**Monks Orchard Residents' Association
Planning**

20th December 2019

**Stage 1 Complaint – Planning Approval Ref: 19/00131/FUL - 17 Orchard Avenue Croydon
CR0 8UB**

Table 3.2 Sustainable residential quality (SRQ) density matrix (habitable rooms and dwellings per hectare)

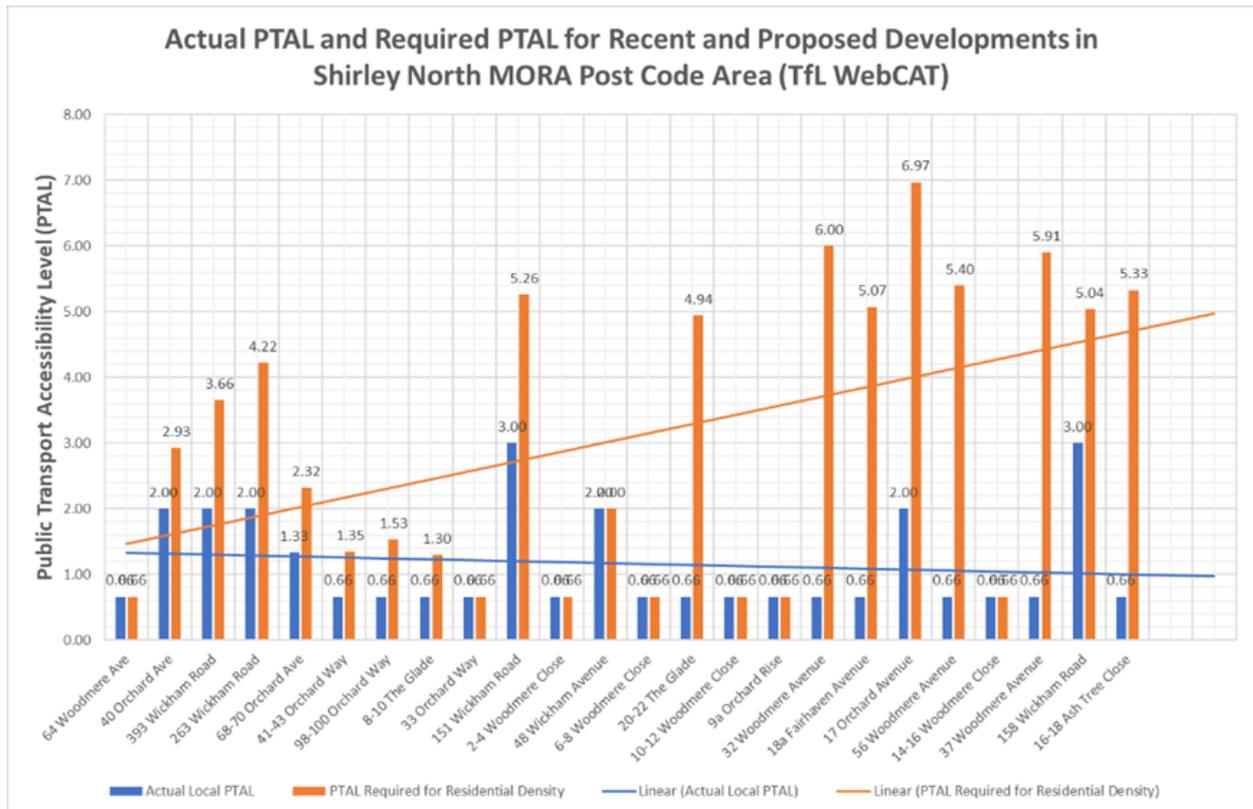
At **30hr** and with a site area of **0.071ha** gives a **Residential Density** as currently calculated at **422.54hr/ha** which requires a **PTAL of 6.97** which is well above the maximum range of PTAL between the broad range of **4 to 6** and not **309.86 hr/ha** which is within the **highest** broad range of **4 to 6** but NOT a PTAL 2 which is the current and forecast for this locality to 2031^[3]. If the proposal is to be determined on the current adopted **London Plan Policy 3.4**, the Density ranges “**within the defined PTAL ranges**” are the “**Broad**” ranges but are constrained within these **PTAL Ranges** and should be interpreted as that at a **Suburban Setting** at approximately **PTAL 2**. The **Residential Density** should be within the “**Broad Range**” of **150 to 250h/ha** but tending toward **150hr/ha** and a **Housing Density** within the “**Broad Range**” of **40 to 80 units/ha** at an average hr/ha of **3.1 to 3.7 hr/unit but tending toward 40units/ha**. There is no other way of interpreting the values in **Table 3.2**.

The Density of **422.54hr/ha** is higher than the highest “**Broad Range**” of **200 to 350hr/ha** which requires a **PTAL of 6.97** (higher than the Highest “**Broad Range**”)

Even if the Case Officer’s calculation of **Residential Density** is accepted based on **22** habitable rooms at **309.86hr/ha** this would require a **PTAL of 5.4648** in the highest range **4 to 6** when the actual PTAL for the locality is just **2** and forecast to remain a **2** until 2031.

The Histogram above illustrates the excessive Residential Densities of recent developments within the MORA Post Code Area required PTAL against the available and forecast PTAL.

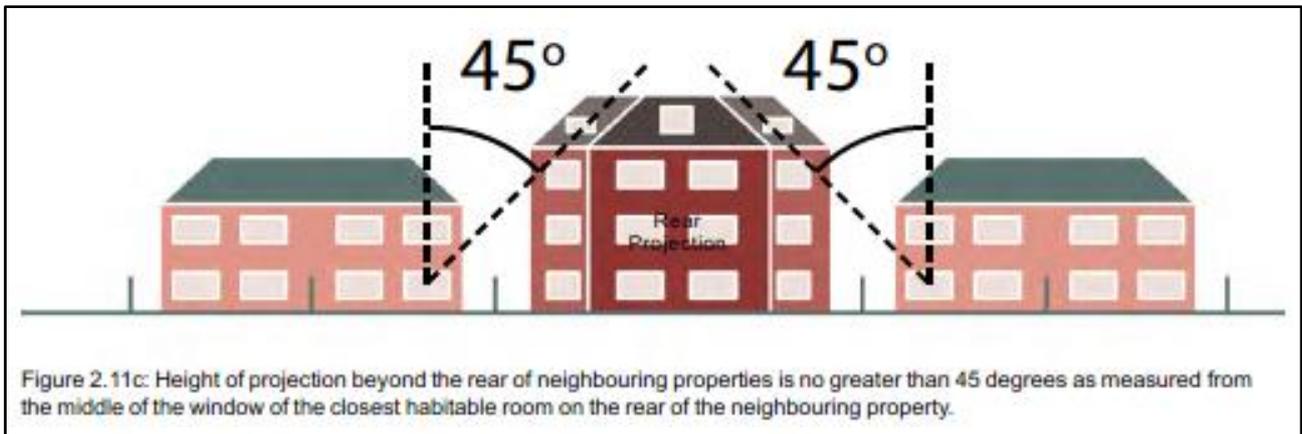
Paragraphs 8.14 and 8.15 of the Case Officer's Report only considers the horizontal 45° Degree Rule and completely ignores the vertical 45° Degree Rule as defined by SPD2 para 2.11. c).

The Case Officer completely ignored the Supplementary Planning Guidance; Chapter 2 – *Suburban Residential Developments (SPD2)* Para 2.11 for height amenity (*45-Degree vertical Rule*) and daylight Para 2.9.

SPD2 Figure 2.11 c) quotes two separate reasons for the 45° Rule. One is the effect on the amenity of the adjacent property and the other is related to Daylight or Sunlight effect on the adjacent property. These also are NOT mutually exclusive; one does not cancel out the other.
